APPLICATION NO.	FILING DATE	FIRST NAMED INVENTOR	ATTORNEY DOCKET NO.	CONFIRMATION NO.
10/604,693	08/11/2003	Perry Wade Schoneboom	23077-00002	1692

Office Action Summary

This is the second office action for application number 10/604,693, Support Bracket, filed on August 11, 2003.

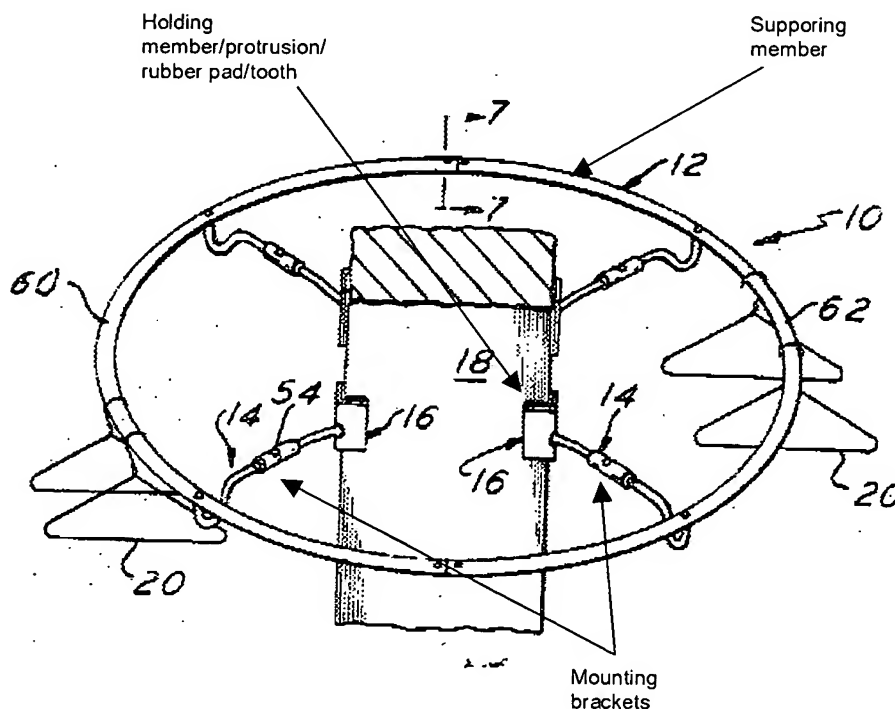
Claims 1, 2, 6-8, 10, 11, 15 and 16 are rejected under 35 U.S.C. 102(b) as being anticipated by U.S. Patent number 3,513,940 to Ussery.

Ussery '940 discloses a bracket assembly (above) comprising at least one mounting bracket (above), and a supporting member connected to the mounting bracket, wherein the supporting member includes a first and second support member (above), wherein the mounting bracket is adjustably connected to the supporting member (above), wherein a hook bracket (above; a "hook" is a "curved device for holding" according to Merriam Webster's Collegiate Dictionary - 10th Edition, so clearly, each of the curved ends of 44 and 48 is considered a "hook" and thus this is a hook bracket) connects the mounting bracket to the supporting member, wherein the hook member is adjustably connected to the mounting bracket (near 42), wherein the mounting bracket is inherently forced against an object (24) when an item is hung from

the supporting member, wherein the supporting member includes at least one extending bracket (above) connected to the mounting bracket, wherein the mounting bracket includes a holding member/protrusion (above).

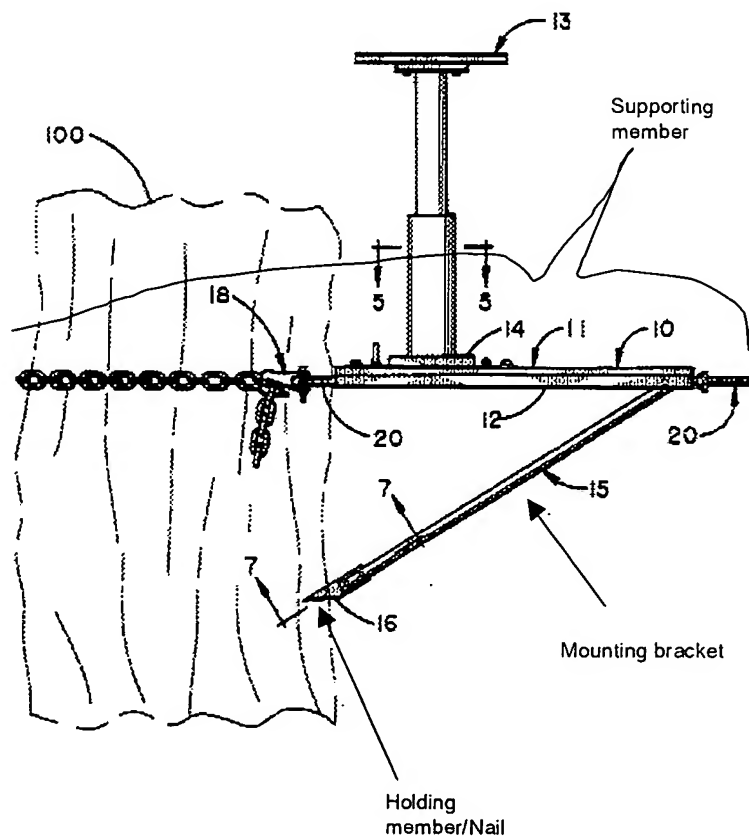
Claims 1, 15 and 18 are rejected under 35 U.S.C. 102(b) as being anticipated by U.S. Patent number 5,355,974 to Miller.

Miller '974 discloses a bracket assembly (above) comprising at least one mounting bracket (above), and a supporting member (above) connected to the

mounting bracket, wherein the mounting bracket includes a holding member/nail (above).
